ORDINANCE NO. 1845

AN ORDINANCE OF THE CITY COUNCIL OF THE CITY OF KELLER, TEXAS, APPROVING AMENDMENTS TO ORDINANCE NO. 1822, APPROVED ON NOVEMBER 1, 2016, AMENDING THE PREVIOUSLY APPROVED PLANNED DEVELOPMENT FOR THE BIRCH TENNIS CLUB AND TRAINING FACILITY, TO ALLOW PERMANENT TENNIS COURT BUILDINGS, LOCATED ON AN APPROXIMATELY 26.99-ACRES OF LAND, BEING TRACT 3D AND 3D01 OUT OF THE DANIEL BANCROFT SURVEY, ABSTRACT NO. 141, LOCATED ON THE WEST SIDE OF KELLER SMITHFIELD ROAD, APPROXIMATELY 400 FEET NORTH OF JOHNSON ROAD, AT 660 AND 680 KELLER SMITHFIELD ROAD, AND ZONED PD-SF-36 (PLANNED DEVELOPMENT-SINGLE FAMILY RESIDENTIAL-36,000 SQUARE-FOOT MINIMUM, IN THE CITY OF KELLER, TARRANT COUNTY, TEXAS; PROVIDING A PENALTY; AND AUTHORIZING PUBLICATION.

The Birch Tennis Club

Planned Development Zoning Standards

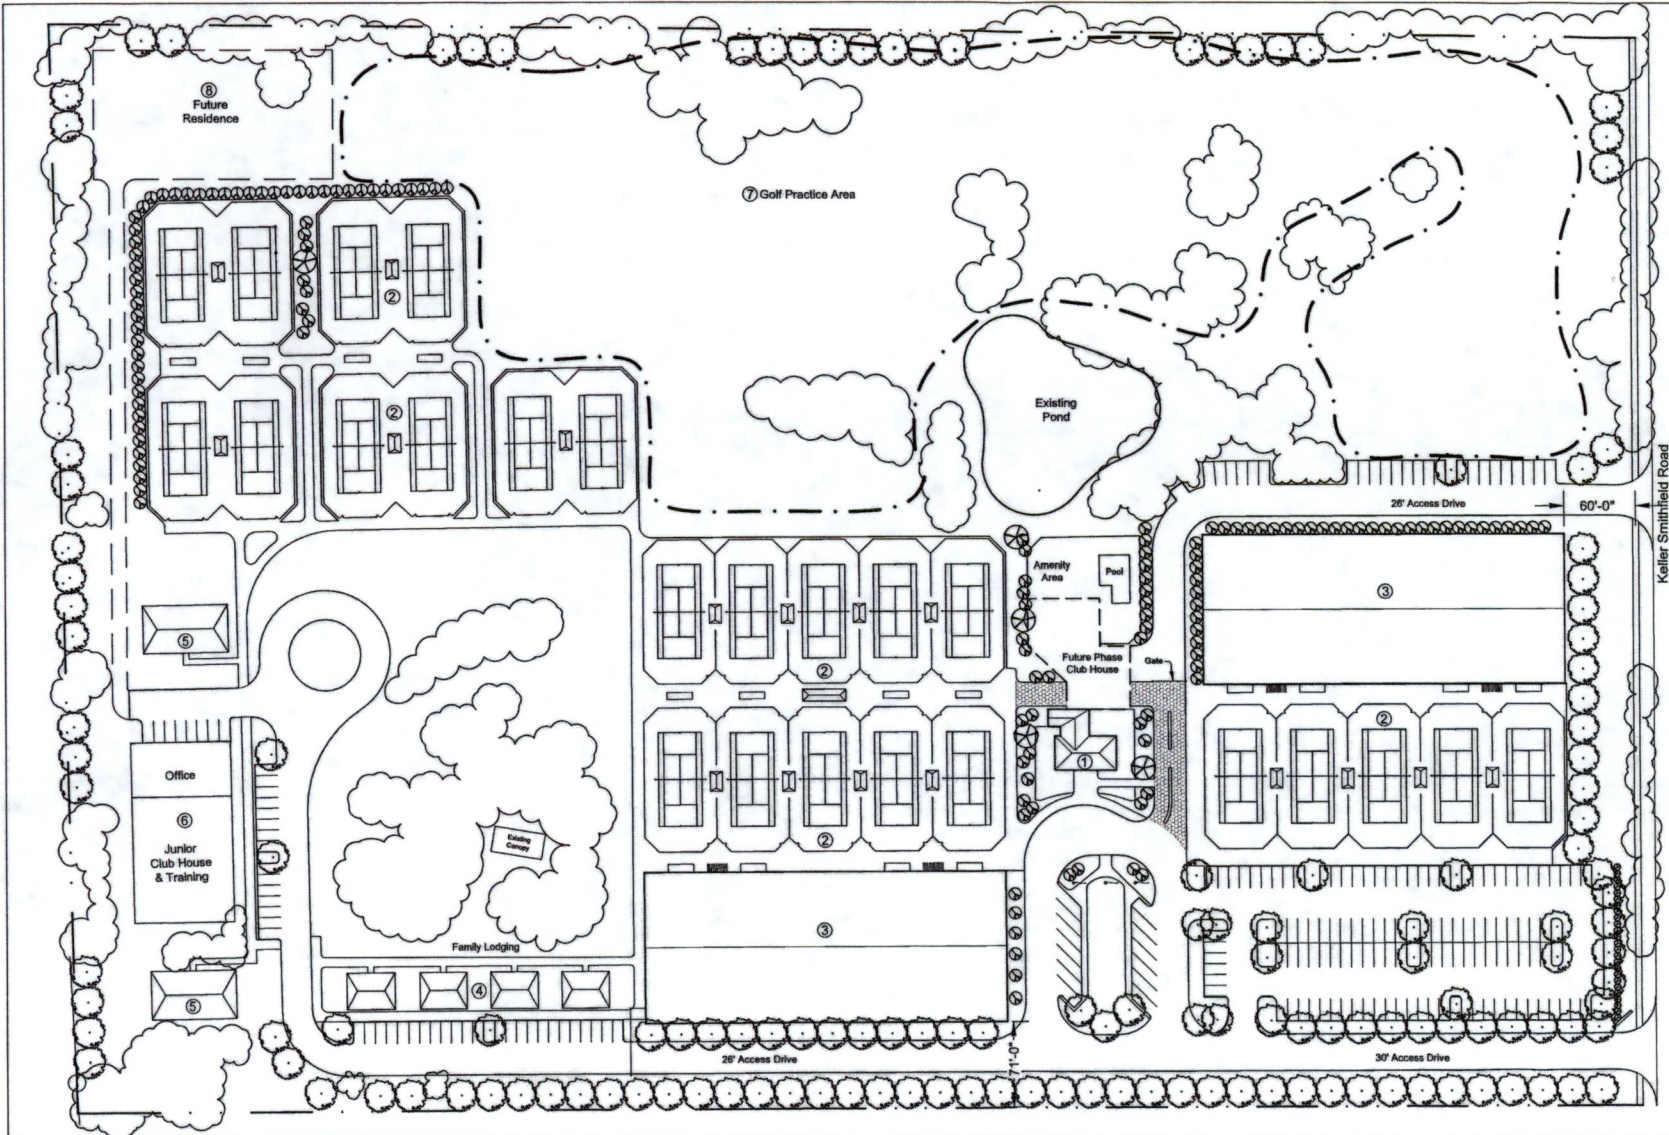
22. The variance to Section 8.06 (A.2) to allow the use of metal panel exterior with "batten board" appearance for the permanent court buildings shall be allowed.

- h. Court Buildings will have exterior finishes similar to the Phase 1 Clubhouse either with batten board or metal panel "batten board" look and stone veneer. Maximum peak height for the court buildings shall not exceed forty-five feet (45').

**THE BIRCH**  
**CONCEPT PLAN**  
Keller, TX

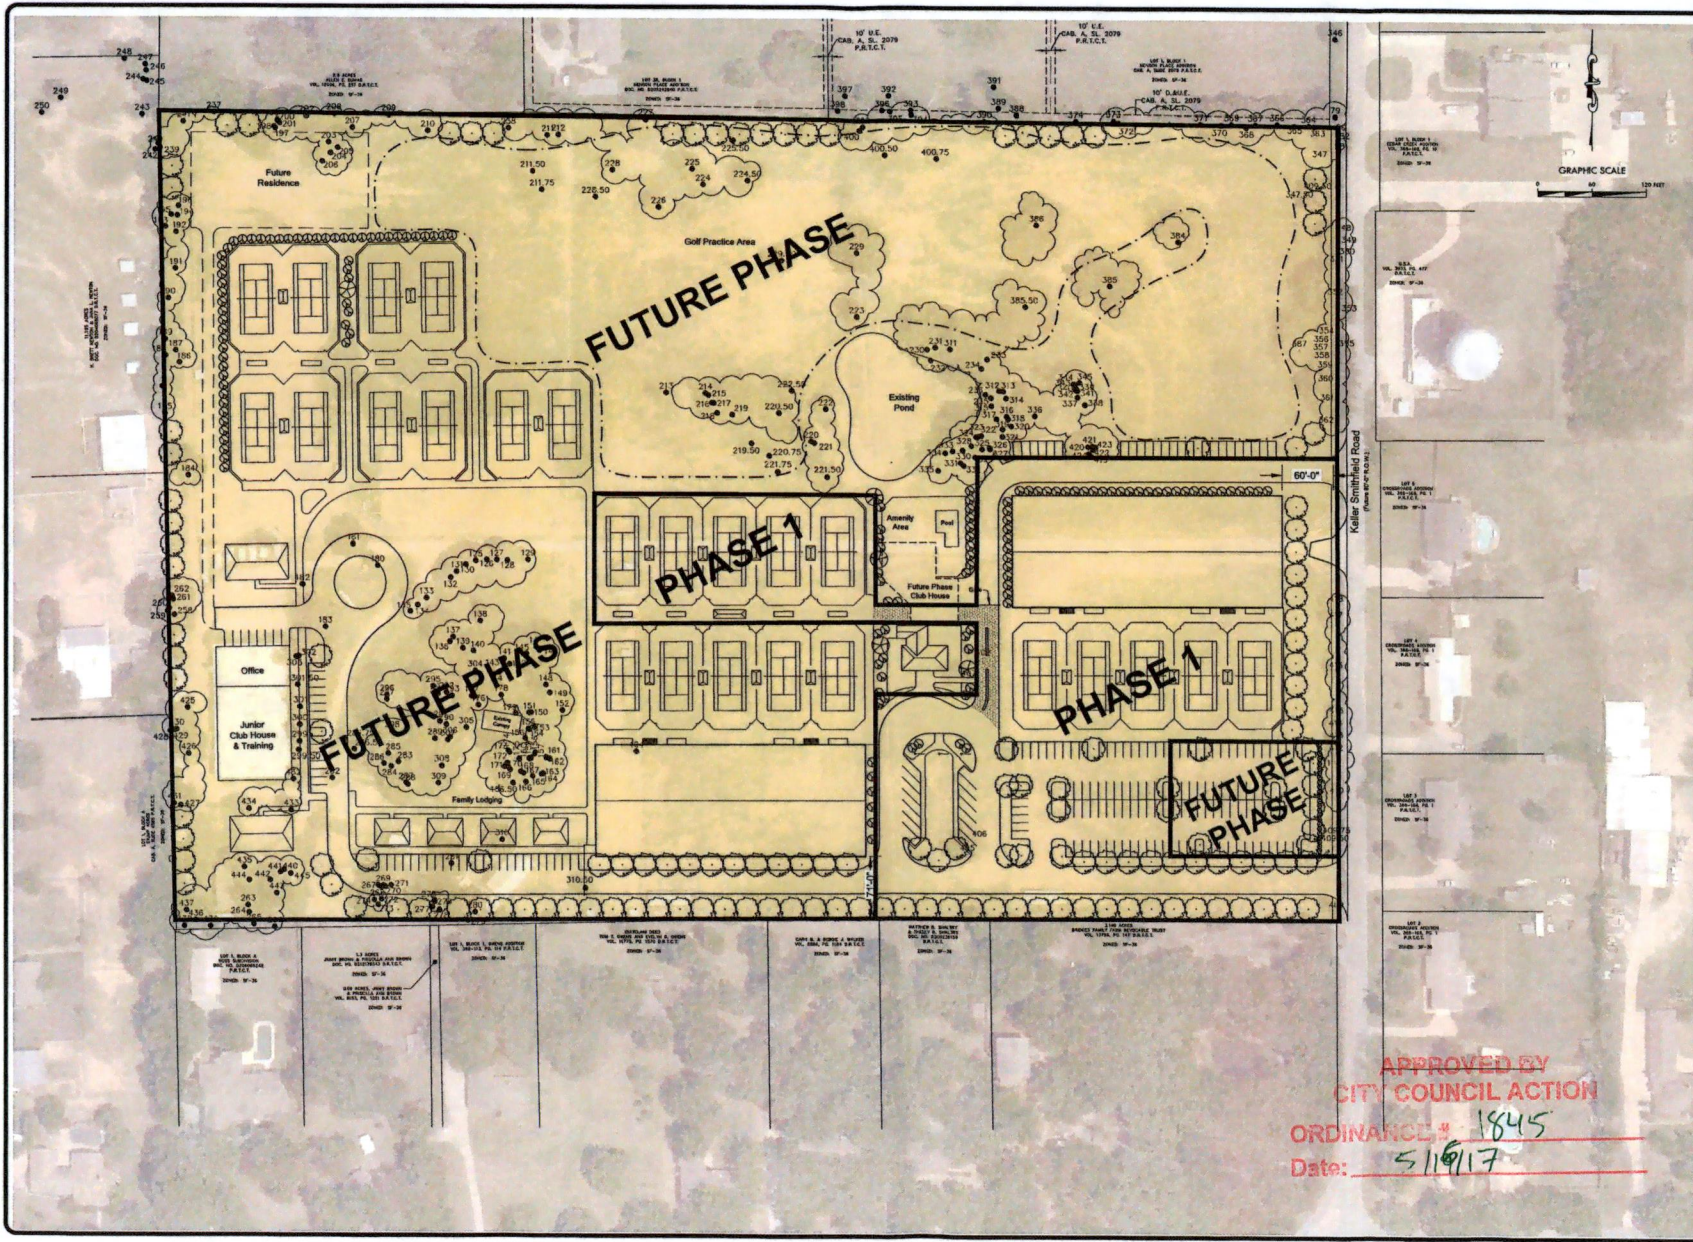
Property will be developed as two (2) lots; one parcel for the Residential (later by subdivision plat); and one parcel for the Birch.

The Birch to consist of three (3) buildings in the ultimate; combined square footage not to exceed 92,000 SF.

Phase II will include 10 additional courts, court building over the five (5) southwestern courts, full drive extension, 36 additional parking spaces, and junior clubhouse.
